Re: Submission against N6 Galway Ring Road Project, PL07.302848

As owner occupiers in Rosán Glas, we (Gwen Cantwell and Oliver Ryan, with three children aged 4, 7, 9 years) object to the positioning of the route of the N59 Link Road South as it will impede our ingress and egress to and from our home and estate, and seriously adversely affect our daily lives.

Figure 1 Cutting from Figure 5.4.01 to 5.4.15_I1 of the N6 EIAR main report, showing N59 Link Road South intersecting with Bóthar Diarmuida. The Rosán Glas estate has been circled in black.

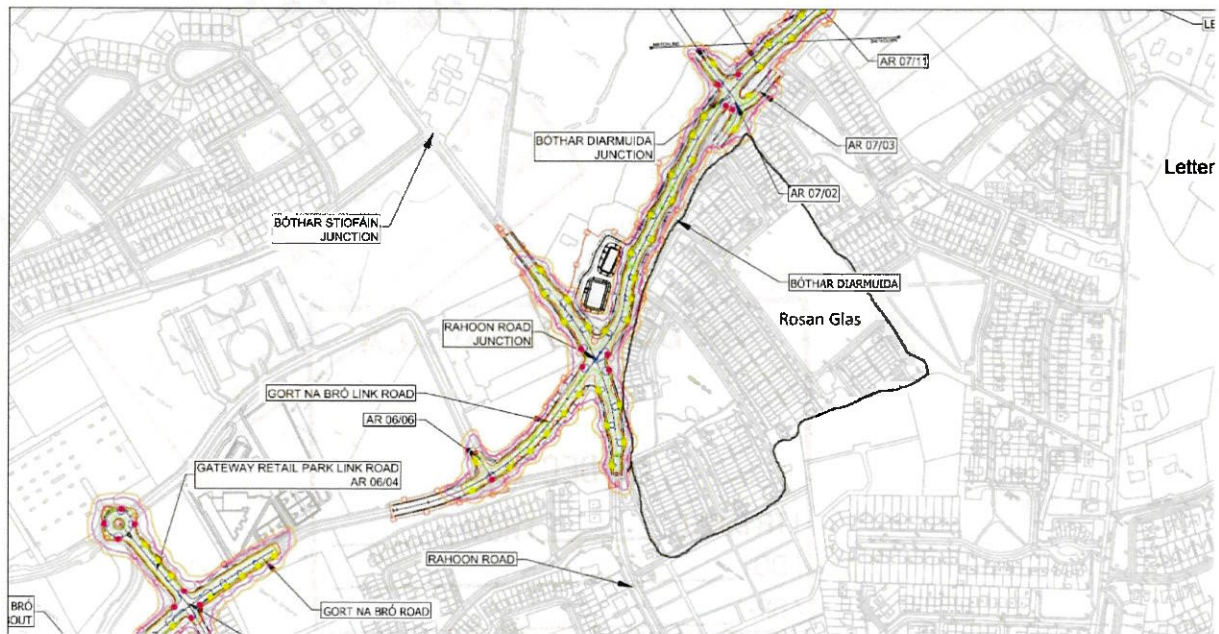
Figure 1 shows that the N59 Link Road South will run parallel to Bóthar Diarmuida before cutting into and blocking the existing Bóthar Diarmuida/Ragoon Road junction, thereby dead-ending Bóthar Diarmuida and cutting off direct access from Bóthar Diarmuida to the Ragoon Road. A new Bóthar Diarmuida/N59 Link Road junction will be created to give access from Bóthar Diarmuida to/from the link road (marked in Figure 1 and *Bóthar Diarmuida junction*). This proposed layout will make Bóthar Diarmuida an internal secondary road to what will be a busy main artery into the area. It will be extremely difficult to leave Bóthar Diarmuida and enter the southern flow of predicted traffic on the link road. It will be even more difficult to try travel north which will require crossing two lanes of busy traffic. This will make life very difficult for us living in Rosán Glas, as the morning and evening rush hour commutes on the proposed link road will effectively prevent us from leaving or entering our estate.

The N59 Link Road/Ragoon Road junction will be a signalised junction. We currently have a free-flow access to the Ragoon Road without traffic lights. However currently at rush hour times the traffic delay and volume is significant, to the point that the Ragoon Road cannot be used to access Bishop O'Donnell Road. Using the signalised junctions in the area as examples (Letteragh Road/Bishop O'Donnell Road, and Ragoon Road/Bishop O'Donnell Road which allow 3-4 cars off the secondary roads onto the main road per light change), the newly proposed lights at the N59 Link Road/Ragoon Road junction will only delay and hinder traffic further on the Ragoon Road, adding to the burden of local drivers and residents.

Figure 2 Snippet from GCOB-SK-R-319 (Emerging Preferred Route Corridor – OS) from the N6 Galway City Transport Project website, <http://www.n6galwaycity.ie/phase-2/public-consultation-no-3/> The circle highlights a possible connection point for the link road discussed in the text.

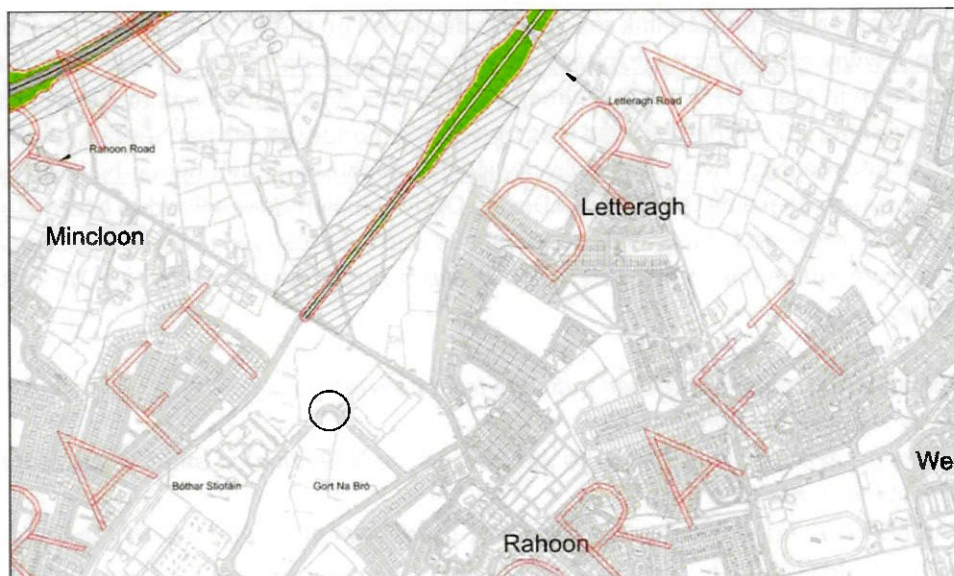
Figure 2 and 3 shows the proposed link road as was displayed on the N6 Galway City Transport Project website (<http://www.n6galwaycity.ie/phase-2/public-consultation-no-3/>) at the time of the final public consultation in May 2015. At that time, the N59 Link Road South was to run opposite Bóthar Stiofán. By November 2015, the link road was moved from opposite Bóthar Stiofán to cut-off Bóthar Diarmuida. The website (<http://www.n6galwaycity.ie/phase-3/chosen-design-option-ballymoneen-road-to-n59-20112015/>) states regarding the "Chosen Design Option: Ballymoneen Road to N59 – 20/11/2015": *Following feedback received from landowner meetings and submissions received, the design option to be progressed from Ballymoneen Road to N59 Moycullen Road has been selected. The design option will incorporate:*

We contend that the same three reasons can and should be used to justify the moving of the link road away from Rosán Glas and Bóthar Diarmuida.

Figure 4 The N59 Link Road South (outlined in black) travels through agricultural lands (peach colour) a designated commercial-industrial, enterprise light industry zone (pink colour) as well as a residential zone (yellow) (Galway City Development Plan 2017-23).

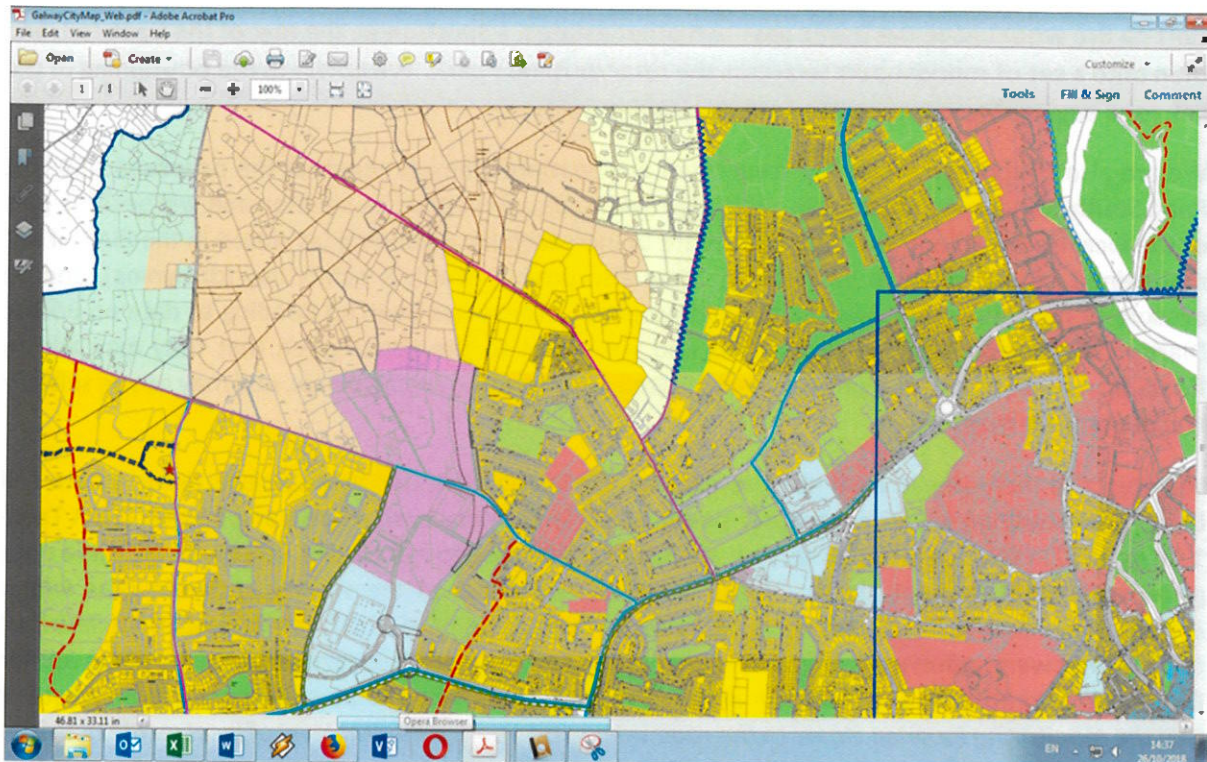
The Galway City Development Plan 2017-23 contains Figure 4 and 5 showing the zoning of lands around Rosán Glas and the Rahoona Road, and the position of the proposed N59 Link Road. The link road is to bisect residentially zoned lands north of Rosán Glas. We object to this.
